10 July 2020

## FORT STREET PUBLIC SCHOOL REDEVELOPMENT RESPONSE TO SUBMISSIONS AND REQUEST FOR ADDITIONAL INFORMATION AND CLARIFICATIONS

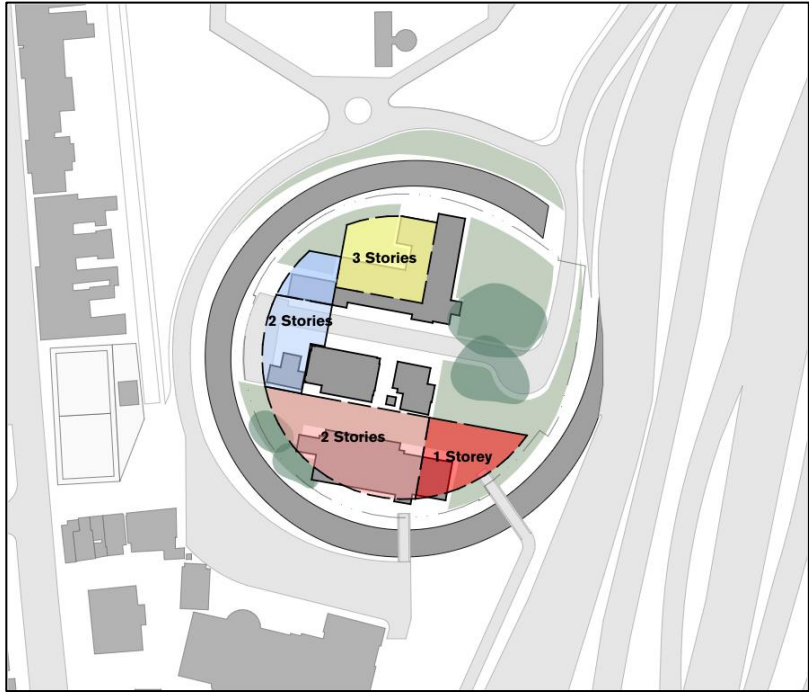
| Item No | Name | Type | Issue   | Response   |
|---------|------|------|---|--|
| 50      |      |      | <p><u>Section 61 Contributions</u><br/>In response to the applicant's request for an exemption from Section 61 Contributions under the Central Sydney Development Contribution Plan, the City will provide the CEO's determination as to whether a s61 contribution is payable in accordance with Section 2.2(c).</p>                             | <p>It is noted that the payment of any contribution on the development is discretionary, and that the approval authority, in this case the Minister for Planning and Public Spaces, while empowered to impose a condition requiring the payment of a monetary contribution is not required to under either the EP&amp;A Act or Council's Contributions Plan.</p> <p>SINSW reiterates that an exemption is appropriate in this instance as the Applicant is a government agency which relies on government funding to provide new facilities for both the school community, and the public. The levying of a development contribution would divert a portion of these public funds, which have been specifically provided to fund the redevelopment of FSPS, to local services without any direct nexus to the impact on those services. The nature of the development is to support the expansion of a public school, so the development will not generate significant demand for new infrastructure. The redeveloped public school will largely provide the type of infrastructure which Council typically seeks to levy for, for use by staff, students and the public.</p> <p>Moreover, the Applicant's position is supported by the provisions of Circular D6 which notes that where the applicant is a Crown authority and the development is</p> |

| Item No | Name | Type | Issue   | Response  |
|---------|------|------|---|---|
|         |      |      |   | for Educational Services, no contributions should be collected for open space, community facilities, parking, and general local and main road upgrades. The exemption from payment of contributions relating to community facilities, public domain and new open space is also considered appropriate, as the school will provide areas of accessible open space and facilities for use by the staff and students, and occasionally by the community.   |
